STAFF RECOMMENDATION
1207 Dallas Avenue
July 17, 2019

Application: Violation/Show Cause; New Construction—Addition and Outbuilding
District: Belmont-Hillsboro Neighborhood Conservation Zoning Overlay
Council District: 18
Base Zoning: R8
Map and Parcel Number: 11801006200
Applicant: Jason Peveler, Peveler Construction
Project Lead: Sean Alexander, sean.alexander@nashville.gov

<p>Description of Project: Staff has ordered a Show Cause hearing for a rear addition and outbuilding that were constructed differently than permitted. The violations were discovered by MHZC Staff on May 21st, 2019 during a routine inspection, and the applicant was notified of the result by email that day. The applicant corresponded with MHZC Staff on June 11th and met on June 13th, and corresponded further by email on June 13th.</p> <p>The applicant is required to appear before the Commission and show cause as to why any original Preservation Permits should not be revoked by the Commission.</p> <p>Recommendation Summary: Staff recommends that the addition and outbuilding be reconstructed in a manner that matches the permits issued in December of 2018: HCP 2018070250 (Addition) and HCP 2018079303 (Outbuilding

Figure 1: 1207 Dallas Avenue

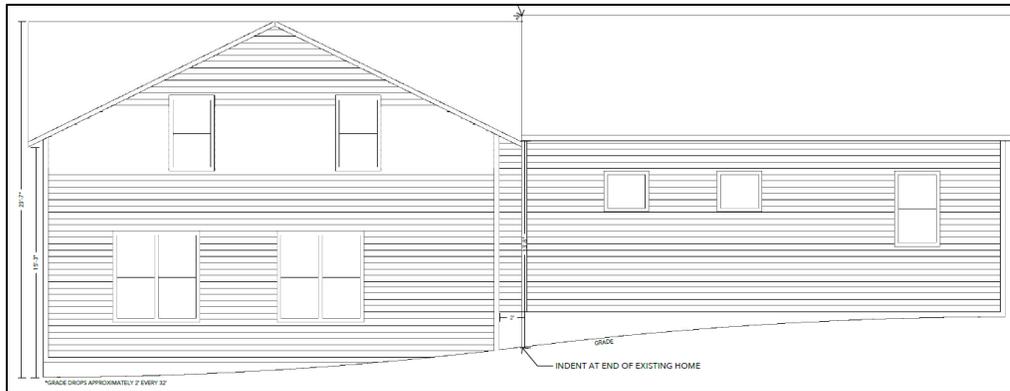
Background: Staff has ordered a Show Cause hearing for an addition and outbuilding that were not constructed in accordance with plans approved by the MHZC in December of 2018.

Figures 2 and 3: Figure 2 is a drawing from permit 2018-070250 showing the eaves of the addition were to be similar to the historic home and the ridge slightly below. Figure 3 is a photograph showing the eave height significantly taller than what was proposed and approved.

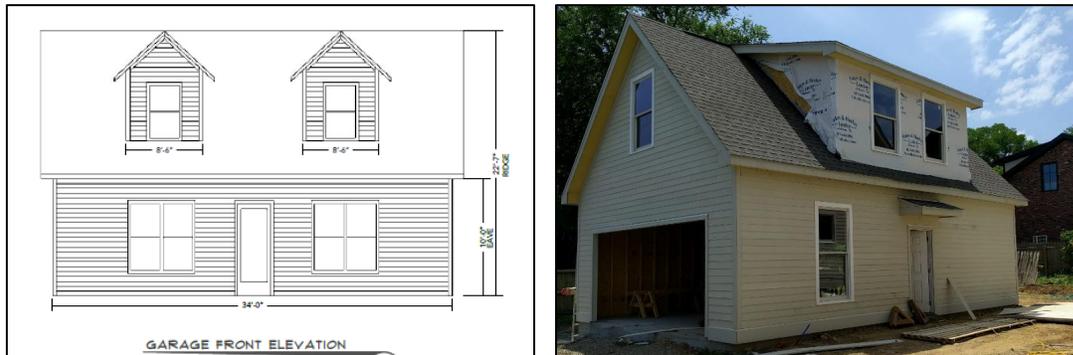
As approved, the addition was to gain an additional story below the primary floor level through a drop in grade, but the eaves of the addition were to align with the eaves of the historic house and the roof was would not be taller than the historic house's roof. The addition was approved to be behind the house and would extend wider to the left side, but would not impact the original front, sides, or roof of the historic building's form.

The addition has been constructed with eaves and a roof taller than the corresponding components of the historic house. The walls of the historic house have not been impacted by the addition, but rather than originating behind the original massing, the roof of the addition originates near the center of the structure, causing it to increase the height of a section of the roof and changing a portion of the gabled roof to a hipped roof.

Figures 4 and 5: Plans for outbuilding at 1207 Dallas on the left and during construction of outbuilding on the right. Note the shape and location of dormer in the photo on the right.

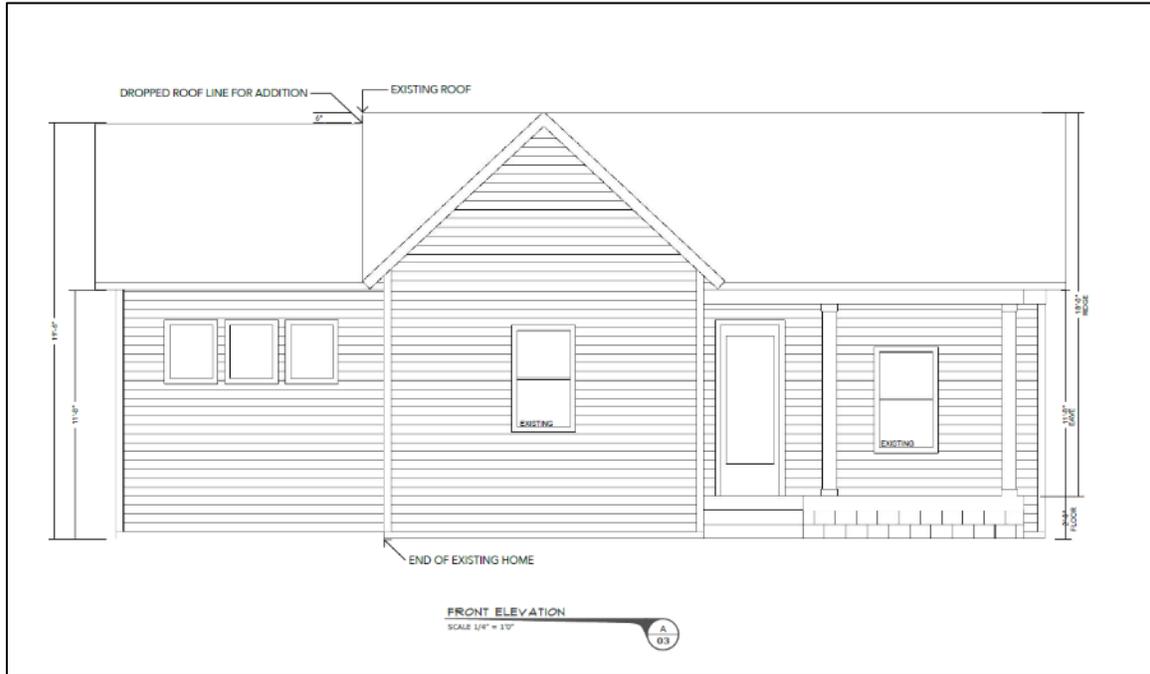
Additionally, the outbuilding was constructed with a shed dormer stacking directly over the wall below, whereas it been approved with gabled dormers stepped back two feet (2').

Outbuilding: The outbuilding was approved to be one and one-half stories with a side-gabled roof with pairs of gabled dormers on both the front and rear. The dormers were approved to sit two feet (2') back from the first story walls below. The building has been constructed with the dormers as approved on the rear facade, but on the front there is a single shed-roofed dormer that is not stepped back from the first story wall. Staff finds that the outbuilding does not meet Section III.B.h. of the design guidelines, because of the wall dormer.

Recommendation: Staff recommends that the addition and outbuilding be reconstructed in a manner that matches the permits issued in December of 2018: HCP 2018070250 (Addition) and HCP 2018079303 (Outbuilding), with the non-compliant portions removed within sixty days (60) of the date of this hearing.

Front elevation of partially-constructed addition to 1207 Dallas Avenue, approved in December of 2018.

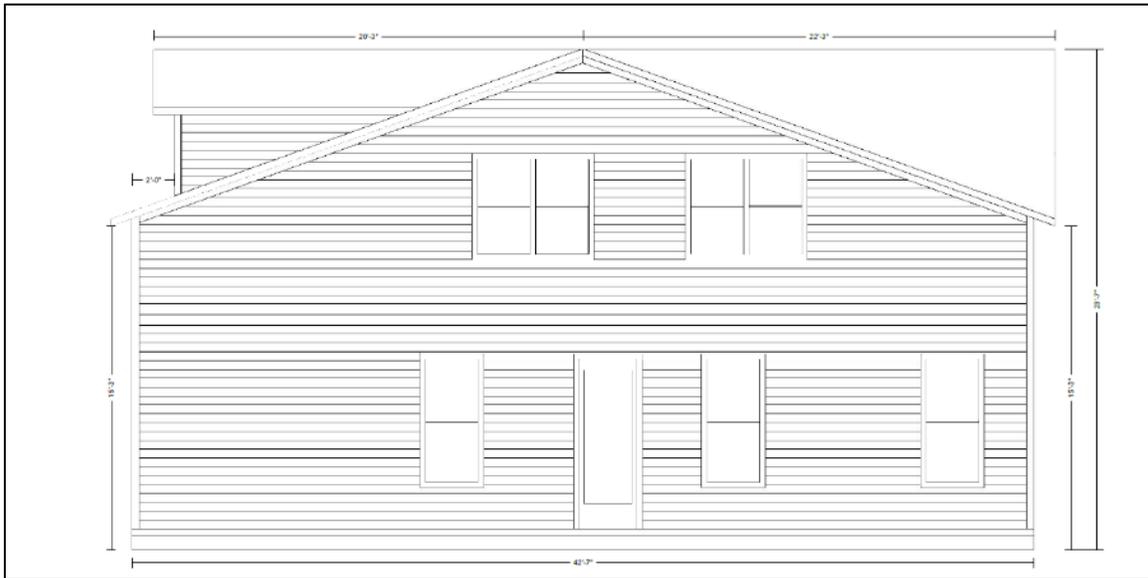
Height & Scale: The addition was originally proposed and approved to be wider than the historic house, extending fourteen feet, six inches (14'-6") to the left side of the original structure, following a two foot by two-foot (2'x2') alcove. The roof ridge of the addition was to be six inches (6") lower than the existing roof ridge, and the eaves were to match those of the existing house. Additions that are wider than the historic home are generally not appropriate but approved, in this case, partially because of the small scale of the addition as compared to the historic building. As constructed, the eaves of the addition are approximately eight feet (8') taller than the original eave line, and the roof is approximately five feet (5') taller.

Staff finds that the eaves, roof ridge height, and overall scale of the addition are not subordinate to the historic house and that the two-story form is not compatible with the one-story historic house, therefore the addition as constructed does not meet sections II.B.1a and II.B.1.b of the design guidelines.
